July 17, 2020

Re: Abbreviated Notice of Resource Area Delineation - Peer Review
Map B3 Block 1 Lots 9, 10 & 11
Map B4 Block 3 Lots 1 & 2
Map B4 Block 4 Lots 4, 5, & 6
Portion of Map B4 Block 2 Lots 1 & 2
Antone Road
Avon, Massachusetts
DEP File No. 099-0178

StreamStats Report

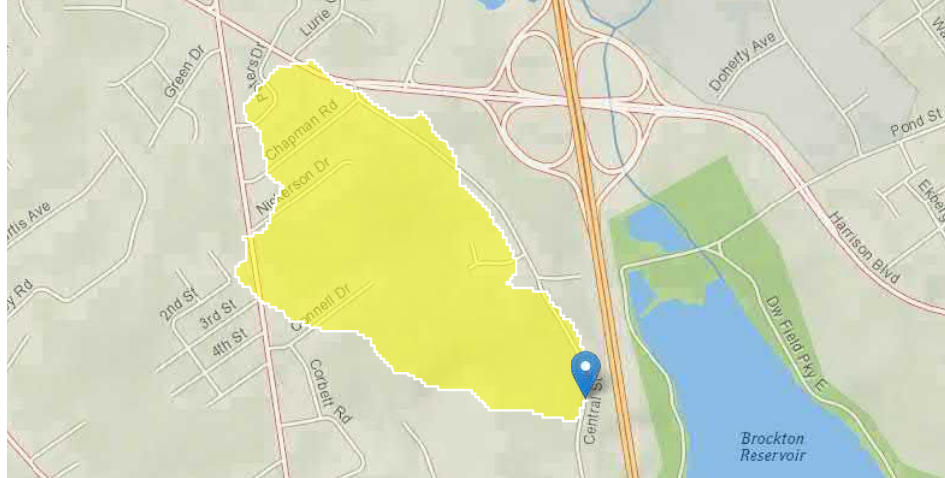
Banks of three intermittent stream channels, Series SC/SD, SE/SF and SA,R/SB were reviewed and found to be accurate in the field and on the Plans. Stream SA,R/SB, located along the southern portion of the Site, was observed flowing during both Site visits. An USGS Streamstat analysis was performed for the

Stream SA,R/SB and it was determined to be intermittent based on the drainage area of less than ½ square mile. The Streamstat tool identified the drainage area to be 0.23 square miles with 0 square mile per mile of stratified drift per until of stream length, see the Streamstat Report attached.
